PERCOLATION TESTING

A 512778

ROAD AND DESCRIPTION 16189 Old Frederick Road Lisbon Md. 21765

RE: Percolation Test Results
Purpose: Relocation of Septic Easement
Property ID: Karras Property - Lot 2
Old Frederick Road Road
Tax Map: 2 Parcel: 31

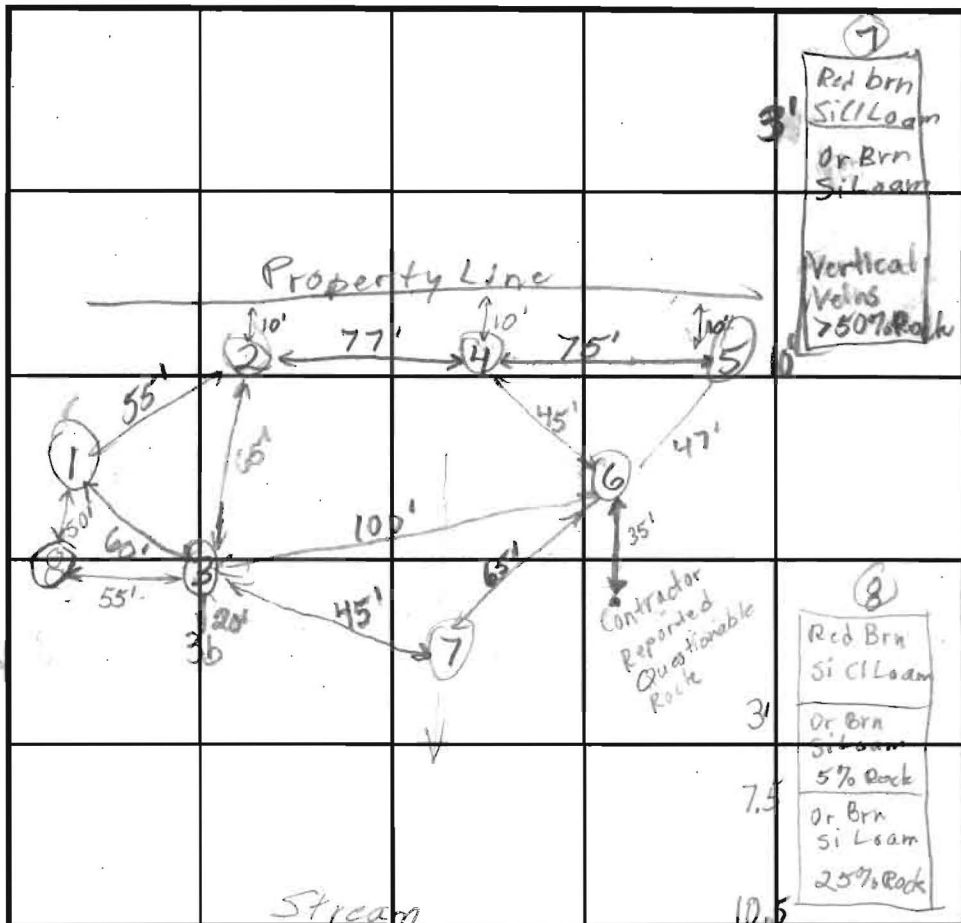
DATE	TEST NO.	DEPTH	PRE-WET		TEST - 1" DROP		TIME	
			START	STOP	START	STOP		
2/15/00	6	3'/10'v	12:19:30	12:26	12:26	12:39:30	3.5	
	5	3.5'/11.5'v	12:24:30	12:42	12:42	1:02	20	
	4	13'v	See Profile				→ O.K.	
	2a	3.5'/13'v	12:48	12:49	12:49	12:51	2	
	b	8'v	12:40	12:43	12:43	12:47	4	
	3	3.5'/11'v	12:55	12:58	12:58	1:03	5	
	1	11'v	See Profile				→ O.K.	
	7	10'v	See Profile				→ F	
	3b	Covered by contractor - Reported Questionable Rock						
	8	10.5'v	See Profile				→ O.K.

REMARKS Overall content of hole #7 ≅ 30% rock fragments, but with severe veins (pockets) of 75% rock.
 TYPE OF SOIL _____
 TESTED BY B. Baker, C.W. ALSO PRESENT Ketterman
 TRENCH DESIGN DATA: AVERAGE PERCOLATION TIME 6 TRENCH WIDTH 3
 INLET DEPTH 2 MAXIMUM BOTTOM DEPTH 4 SQ. FT./BEDROOM 180

* Trench Spacing to be 7' Edge to Edge *

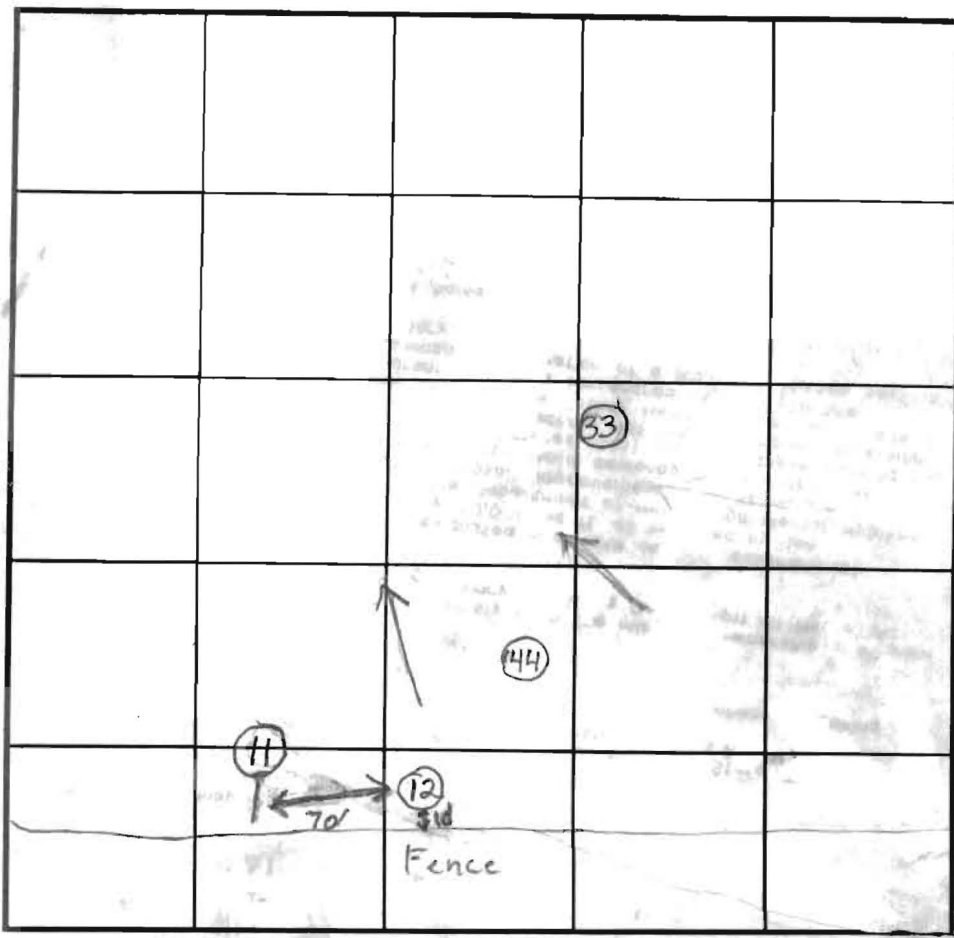
DATE	TEST NO.	DEPTH	PRE-WET		TEST - 1" DROP		TIME	
			START	STOP	START	STOP		
9/25/00	44	14'V	- Requires Wet-season Monitoring					
	11	11.5'V	- Excess Rock, See Profile → (F)					
	33	8.0'V	- Caving at 7.0' → (F)					
	12	4'/13'V	12:30	12:32	12:32	12:36:30	4 1/2 (Wet Season)	
4/5/01	Water 7'8" below grade in monitoring pipe at test hole 44.

REMARKS Monitoring pipe placed in hole #44 to check
 TYPE OF SOIL water level during wet season.
 TESTED BY Brian Baber, Craig Williams ALSO PRESENT Mark - South Carroll
 TRENCH DESIGN DATA: AVERAGE PERCOLATION TIME _____ TRENCH WIDTH _____
 INLET DEPTH _____ MAXIMUM BOTTOM DEPTH _____ SQ. FT./BEDROOM _____

Percolation testing conducted Monday, September 25, 2000, on the above referenced property, showed questionable soil conditions due to the shallow depth of the water table and excess rock in hole 11. A monitoring pipe was placed in test hole 44 for further water table evaluation during the spring wet season when water table levels are usually at their highest. A minimum of a four foot buffer has to be maintained between the bottom of the installed system and the water table. This four foot soil buffer treats the sewage and lessens the chance of ground water – well water contamination. In consideration of the soil characteristics seen during the perc testing, a system could be installed at a depth of five feet. Water seepage was seen in hole 44 at ten and a half feet. At present this represents an acceptable soil buffer. However, as I stated previously, this water level may change during the spring wet season which is the reason for the monitoring.

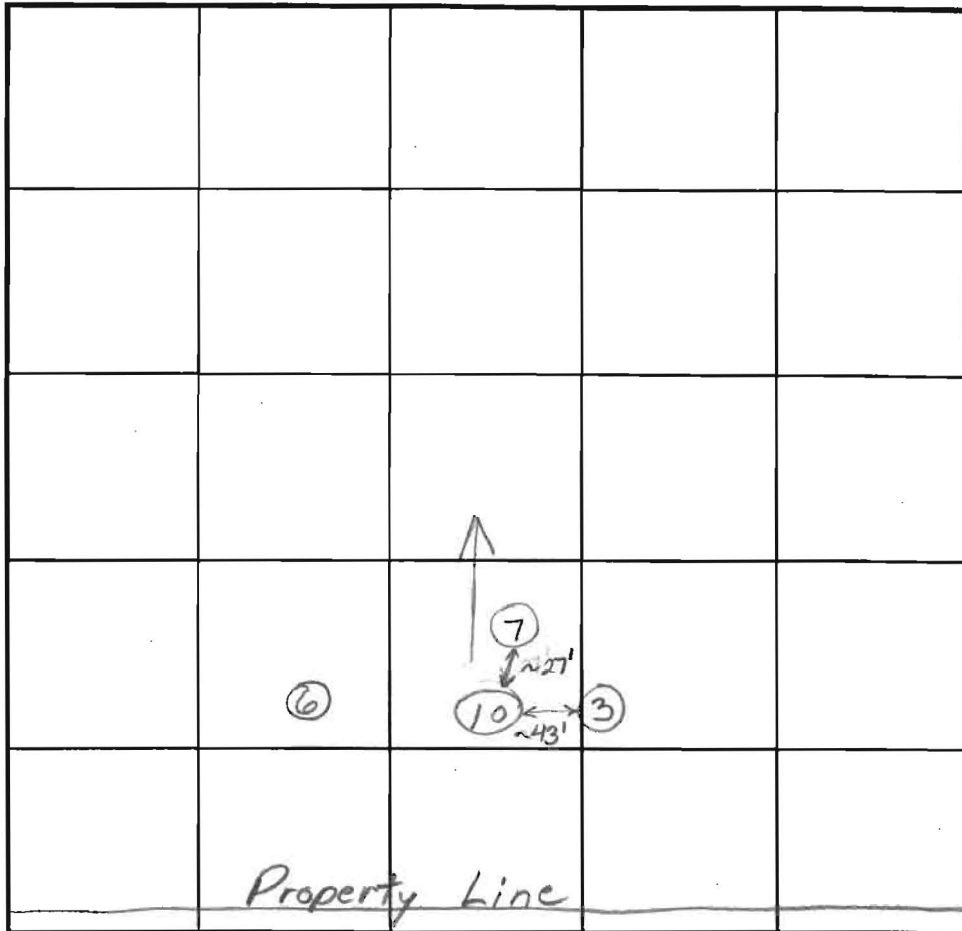
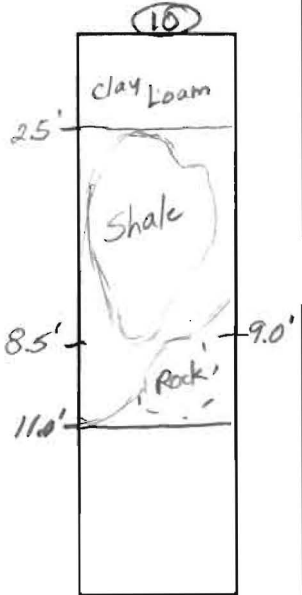
DATE	TEST NO.	DEPTH	PRE-WET		TEST - 1" DROP		TIME
			START	STOP	START	STOP	
8/8/00	10	3' / 11' V	1:33:30	1:35:15	1:35:15	1:39:45	4.5
	(shale)	6.5'	1:36:30	1:37:30	1:37:30	1:39:30	2
	Repair		1:45:15	1:48:00	1:48:00	1:51:00	3
	Failed Due to Rock and Fast Perc Time

REMARKS Similar to Hole 7 but with less shale and partial
 TYPE OF SOIL hard bottom - 4 ft. treatment area not established
 TESTED BY Brian Baker ALSO PRESENT Greco, Ketterman
 TRENCH DESIGN DATA: AVERAGE PERCOLATION TIME _____ TRENCH WIDTH _____
 INLET DEPTH _____ MAXIMUM BOTTOM DEPTH _____ SQ. FT./BEDROOM _____

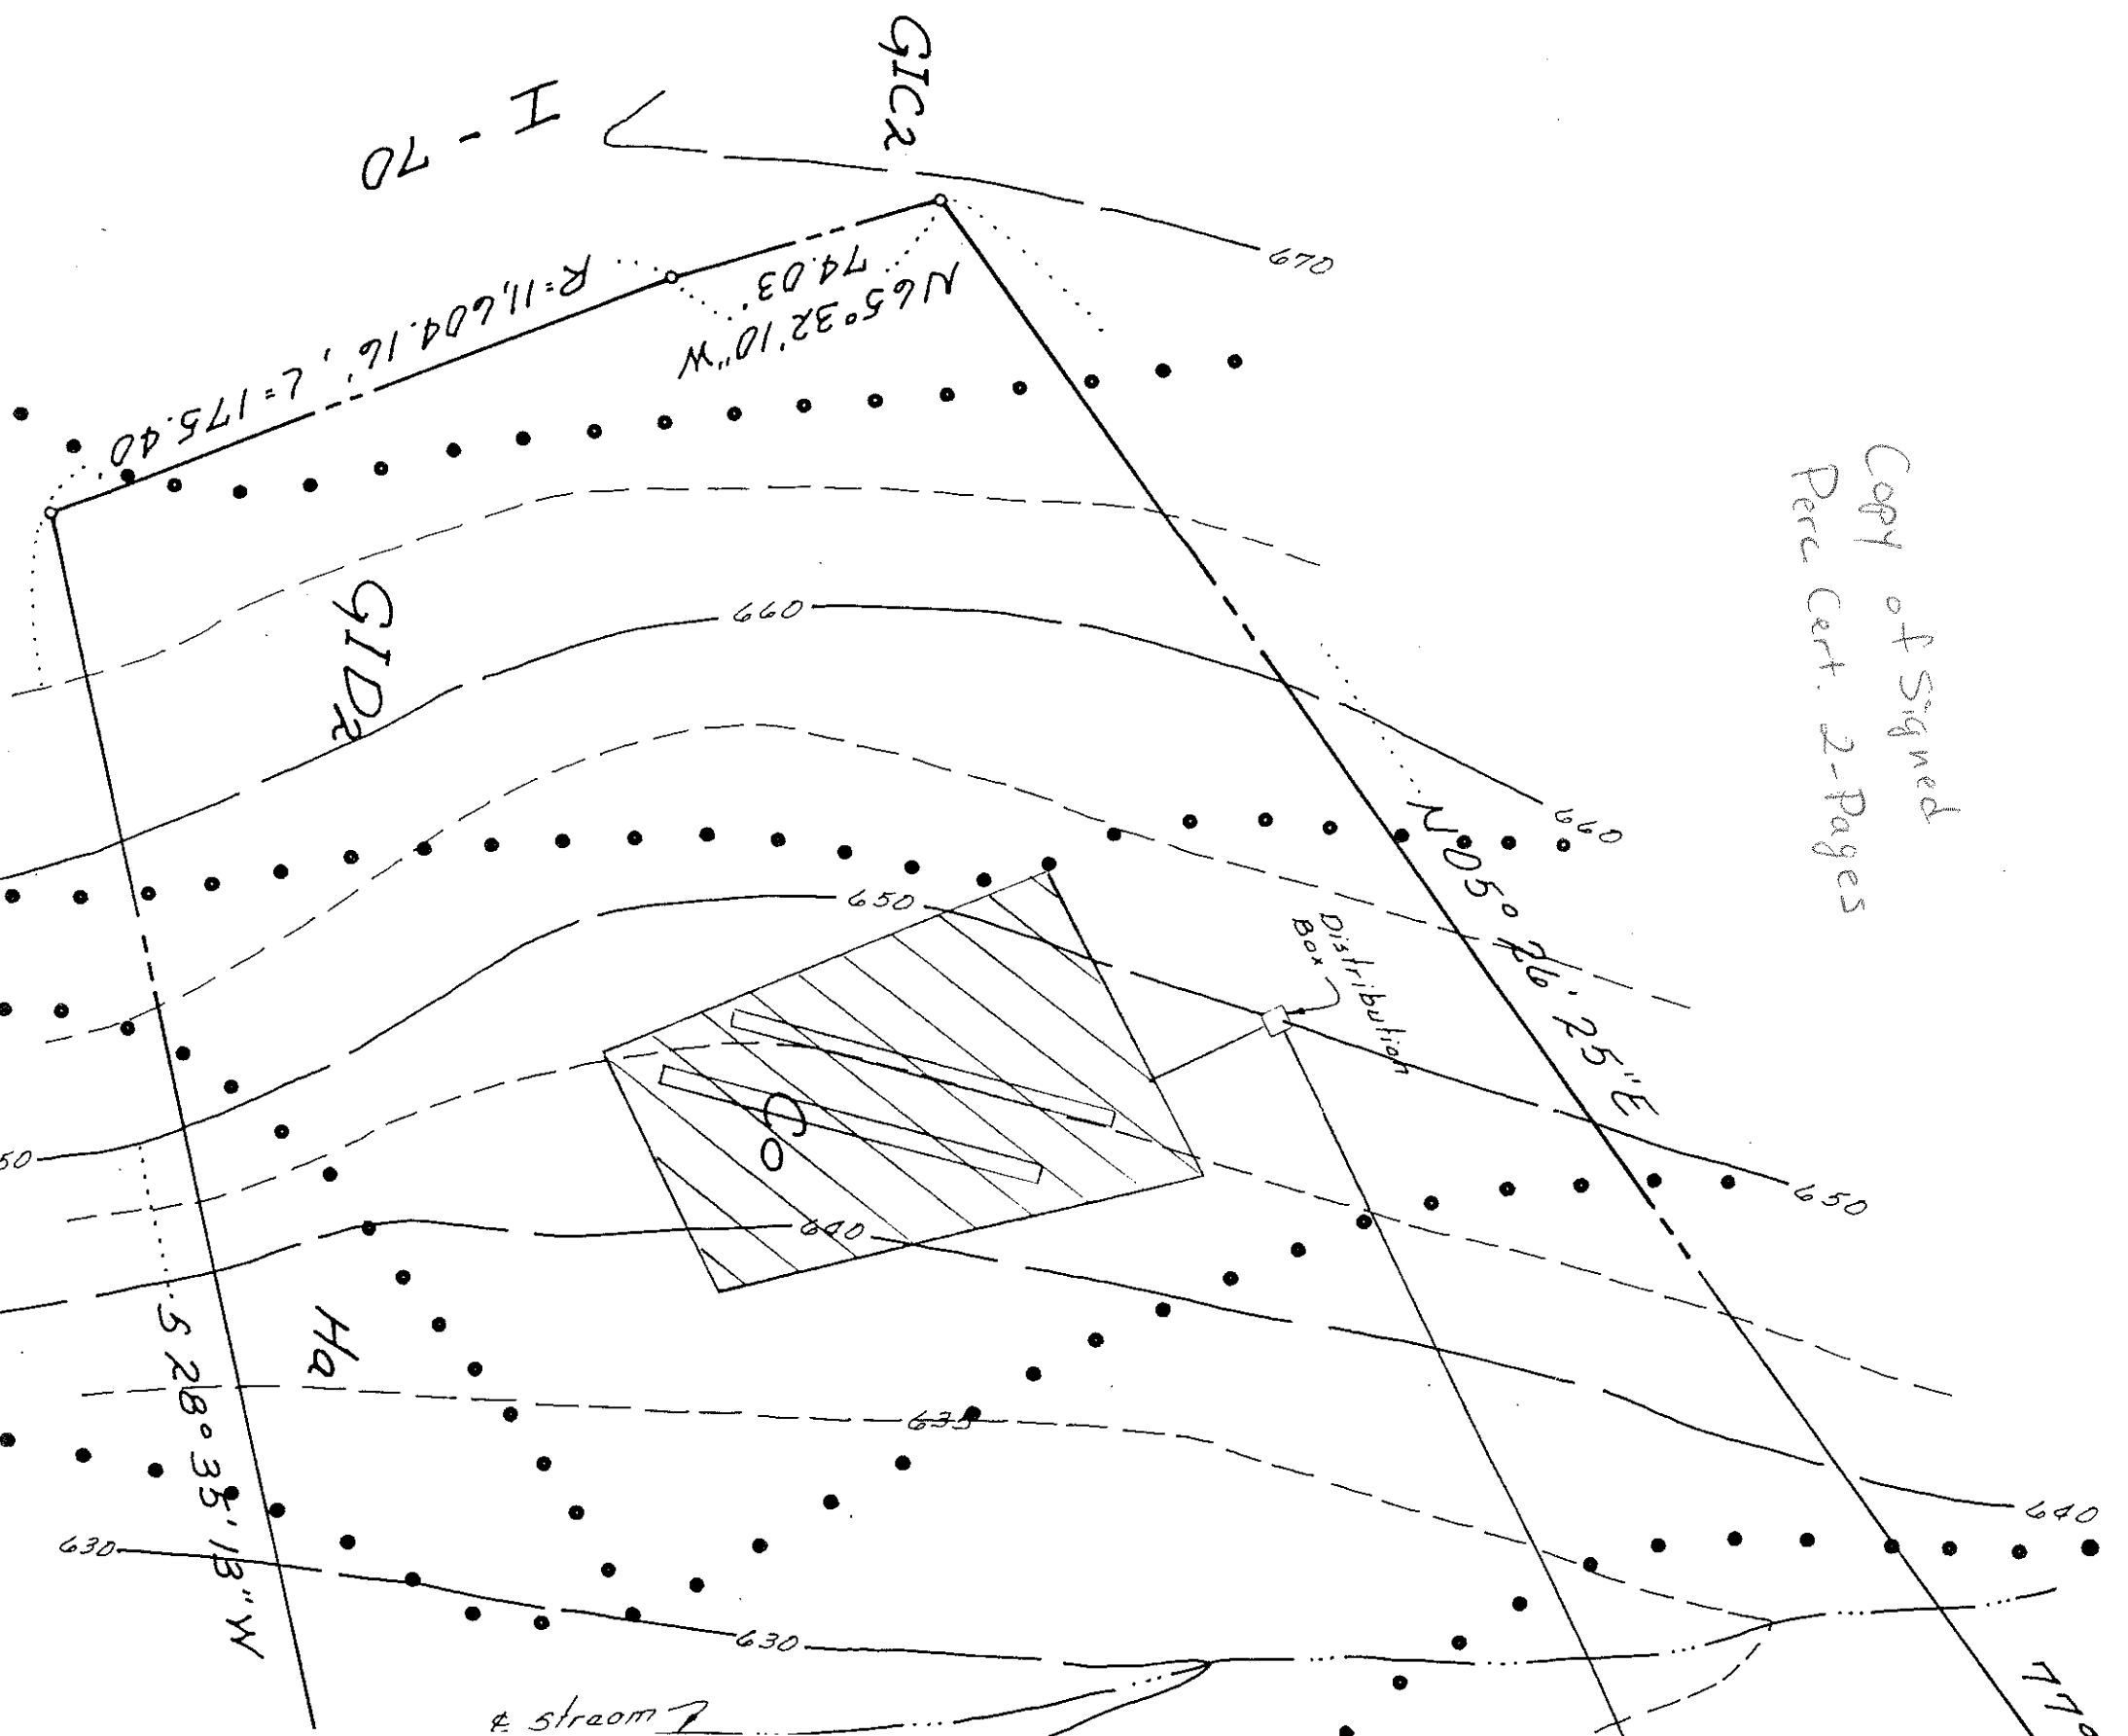
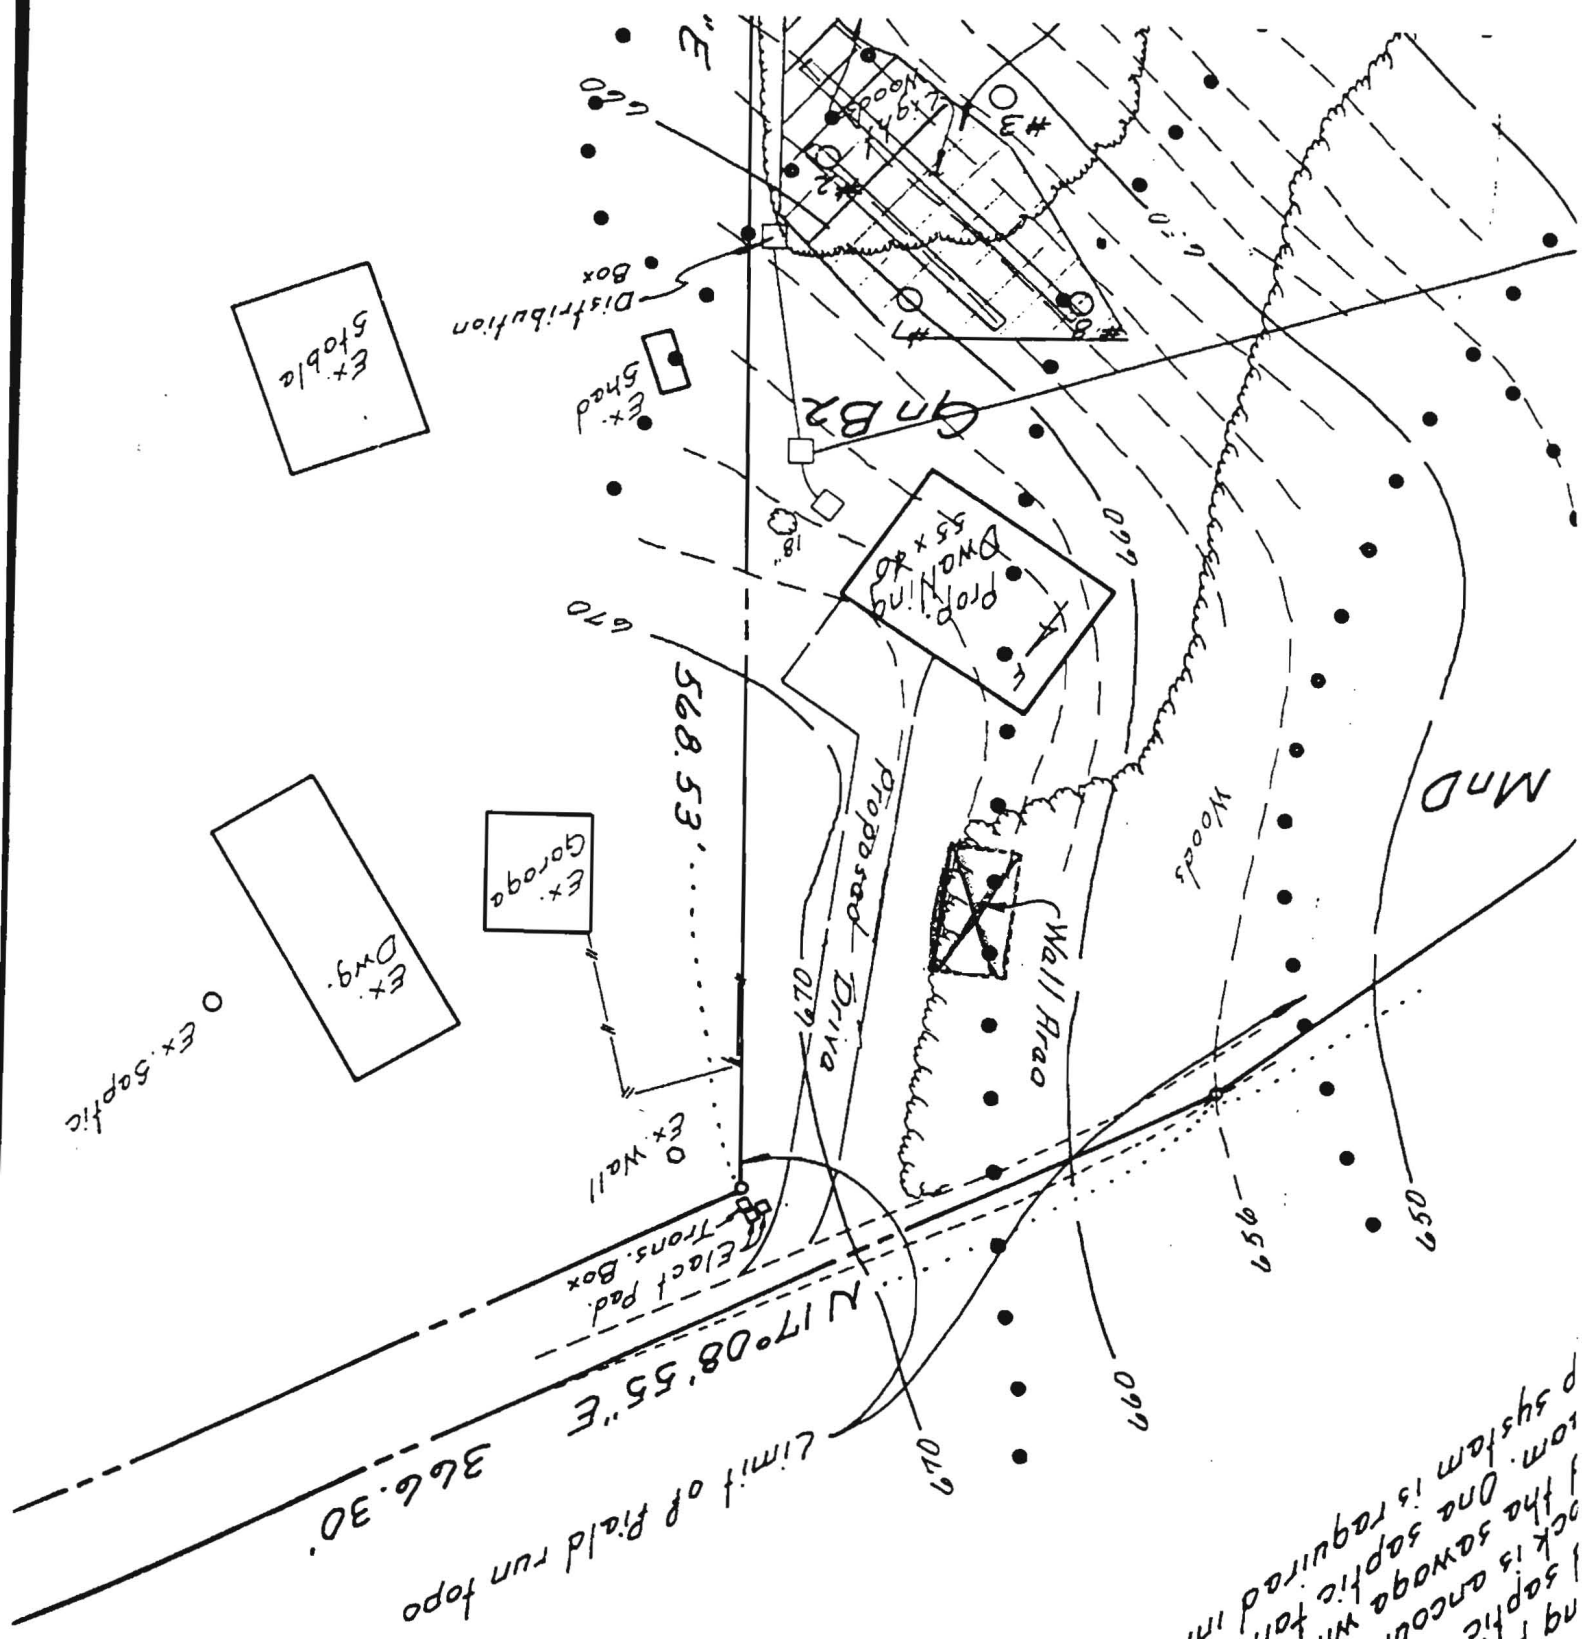
● Danofas Parc Hole Failed

Due to the marginal
excessive soil pad
the gravity
the the tank
to pump future
for
